29a Frognal 2023/4302/P

Photos for 2023/4302/P – 29a Frognal, NW3 6AR

Delegated Report (Members' Briefing)		Analysis sheet N/A / attached	Expiry Date: 04/12/2023	Consultation Expiry Date: 17/12/2023
Officer Sam FitzPatrick			Application Number(s) 2023/4302/P	
Application Address 29A Frognal London NW3 6AR			Drawing Numbers Please refer to decision notice	
PO 3/4	Area Team Signature	C&UD	Authorised Officer Signature	
Proposal(s) Erection of single storey extensions at ground floor to front and rear, replacement and enlargement of existing ground floor side extension, and installation of rear dormer and rooflights. Various external works including erection of refuse store and cycle storage, installation of green wall, and landscaping to garden area.				
Recommendation(s):		Grant conditional planning permission		
Application Type:		Householder Application

Figure 1. Plan (left) and elevation (right) drawings showing 45 degree test for rear extension.

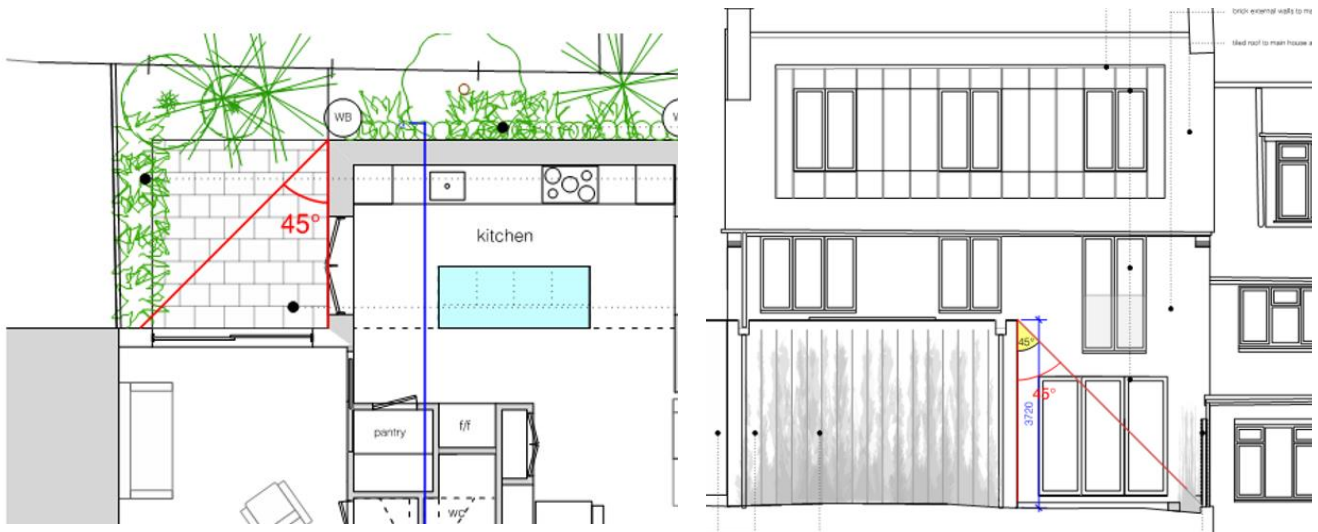
5.6. The two drawings below (figure 1) show that there is no neighbouring window that lies within 45 degrees of the proposed rear extension when measured in both plan and elevation drawings. The only windows lying within this belong to the host property, so there is not likely to be any significant impact on daylight and sunlight from the rear extension.

Figure 2. Plan (left) and elevation (right) drawings showing 45 degree test for front extension.

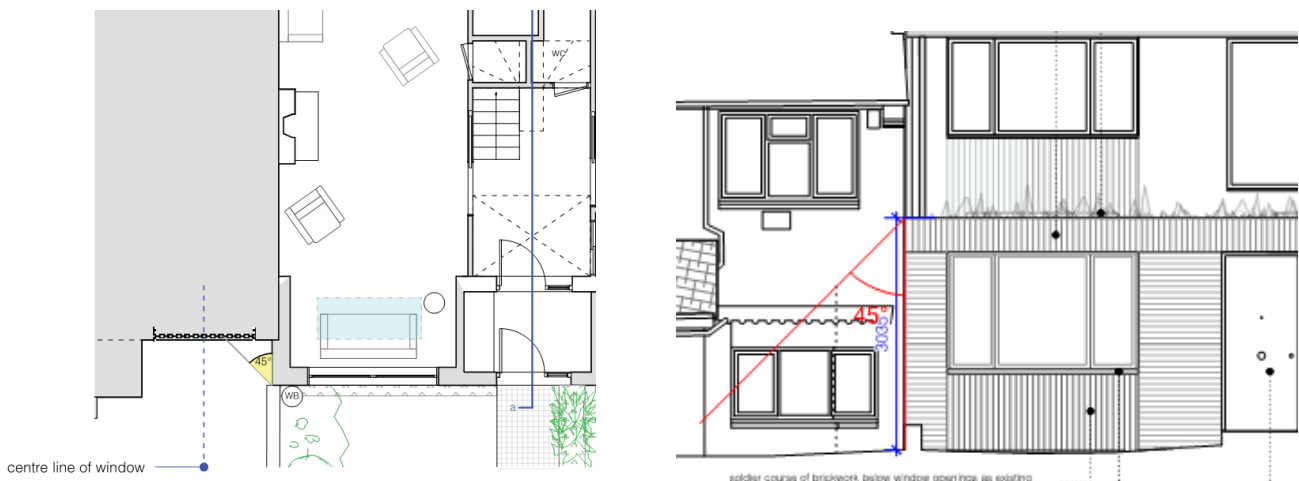
5.7. The two drawings below (figure 2) show that, although the neighbouring window at ground floor level does fall within 45 degrees of the front extension when measured in elevation, the

same window does not fall within 45 degrees when measured in plan. There are no other windows that would fall within 45 degrees, so it is not considered that there is likely to be any significant impact on daylight and sunlight from the front extension either.
